Errata No. X42A-P-001-01

Device: S1D13700F00A100

The following problems exist for the S1D13700F00A100. This document outlines the problems and provides possible work-arounds.

Problem Description: External Connection Change for MC68K Interface

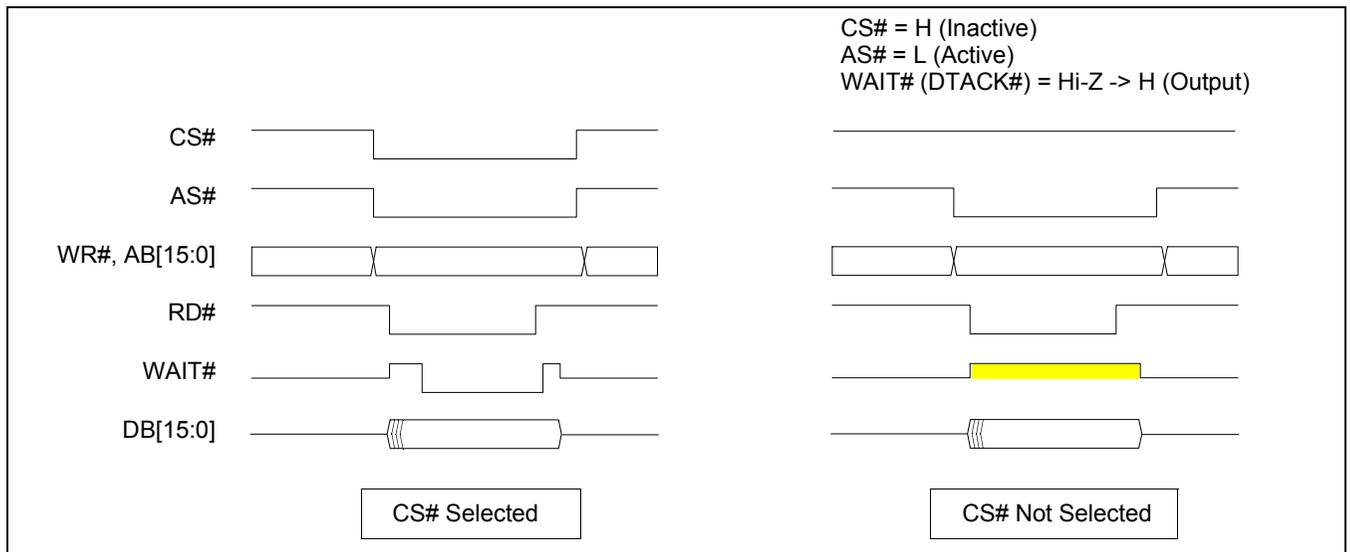
The problem occurs when the MC68K family MPU is selected (CNF[3:2] = 11b) and the WAIT# (DTACK#) output signal is used. In this case, a gate circuit must be added on the system board.

Work-around

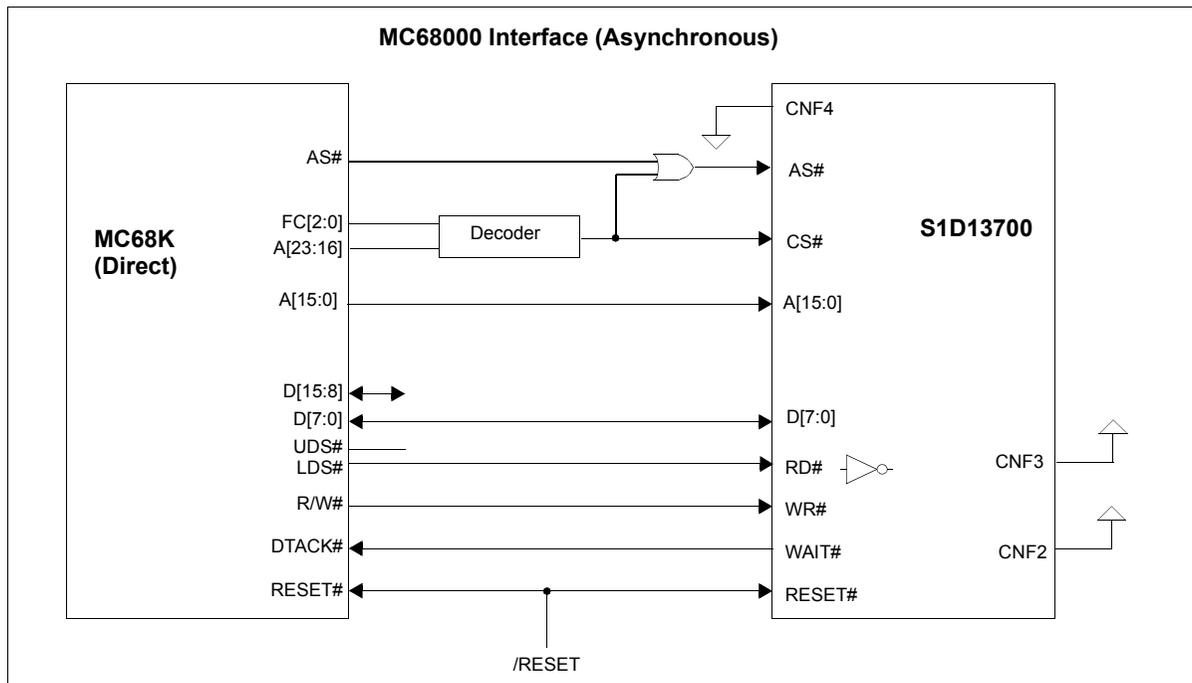
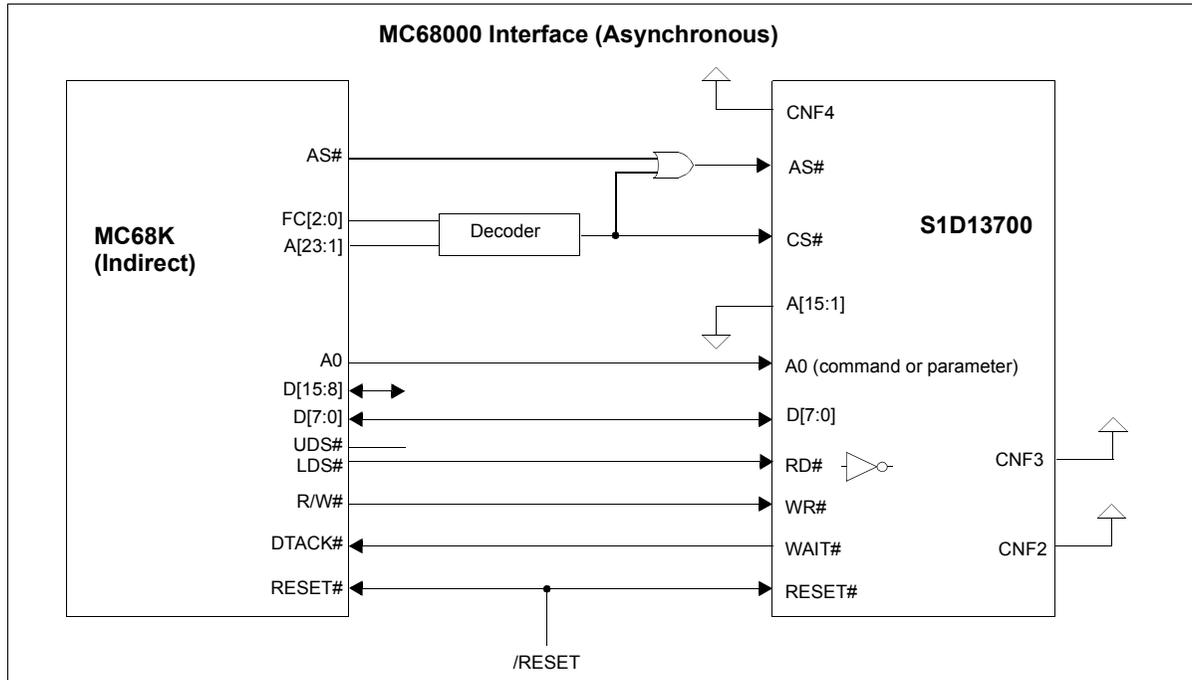
WAIT# (DTACK#) is a tri-state output pin. When CS# is not selected, the S1D13700 should place the WAIT# pin in a Hi-Z state. However, the S1D13700F00100 drives the WAIT# pin to the H level as shown by the yellow colored pulse in the following chart.

A possible work-around for the problem is to make an additional circuit on the system board. Add an OR gate circuit to system board as shown in the following diagrams. When this OR gate is added to the S1D13700 AS# input, the S1D13700 remains in a high impedance state for WAIT# (DTACK#) output even when CS# is not selected.

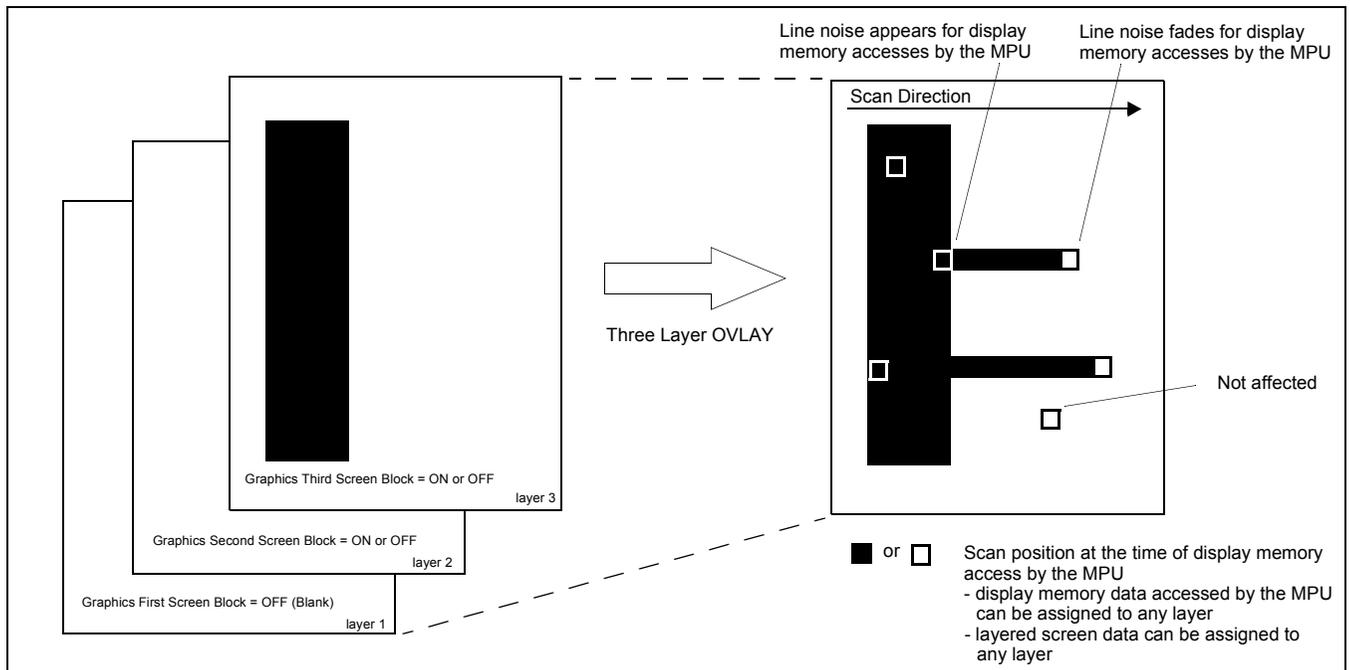
When overlaying three layers, the S1D13700 scans display memory data line by line and then displays it. If the display memory is accessed by the MPU while the S1D13700 is scanning, data shown on the display is fixed to the data scanned. If access to the display memory does not continue, the display state returns to normal from the next frame onward.

The following diagram shows how the problem appears on the display. Random line noise appears to the right of the black and white border, only while the MPU is accessing the display memory.

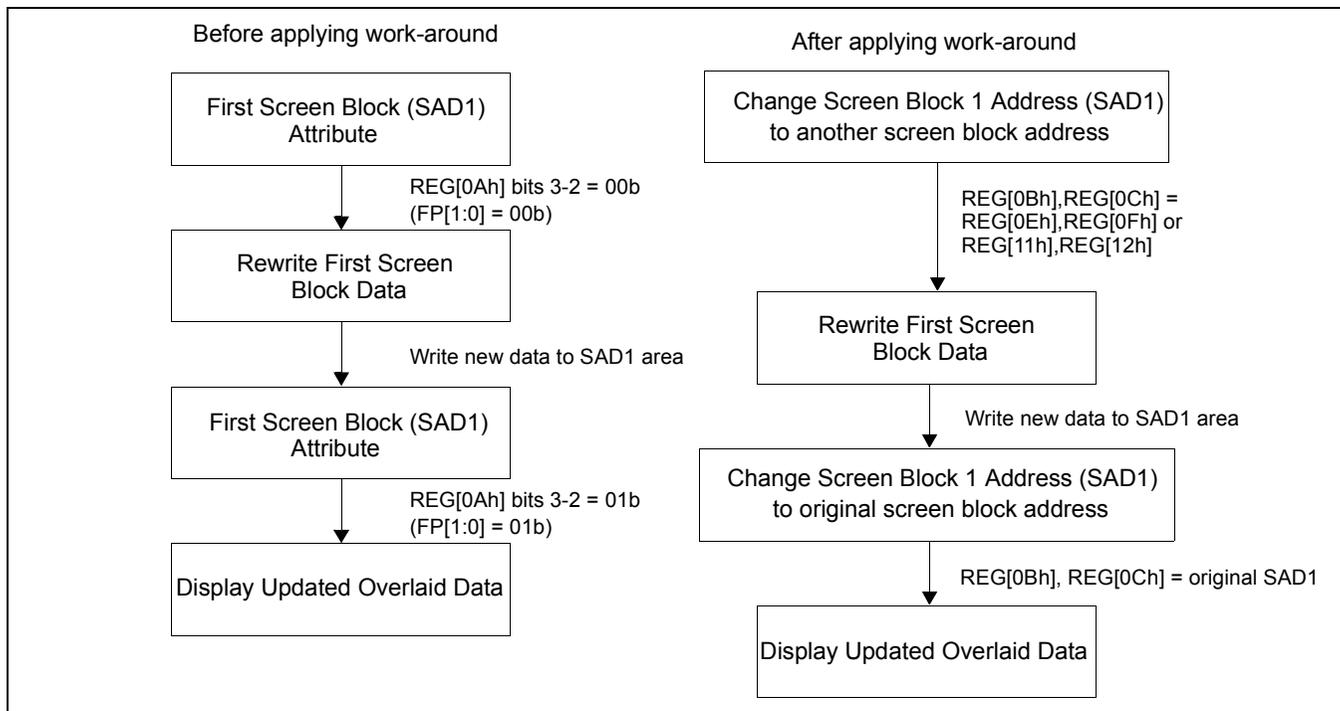
The flow on the left sets first screen block attribute to “off”, accesses the display memory, and then returns the attribute to “on”. This flow will allow the problem to occur.

There is a software work-around for this problem. The following flowchart shows two example flows. The flow on the left does not use the work-around and will cause the problem to occur. The flow on the right demonstrates the work-around and will avoid the line noise problem.

The flow on the right changes the first screen block address to the same value as another screen block address instead of setting the attribute to “off”. This causes the first layer not to be displayed while the display memory is being updated by the MPU. Once the display memory update is complete, the screen block address can be returned to the original address. This flow avoids the line noise problem.
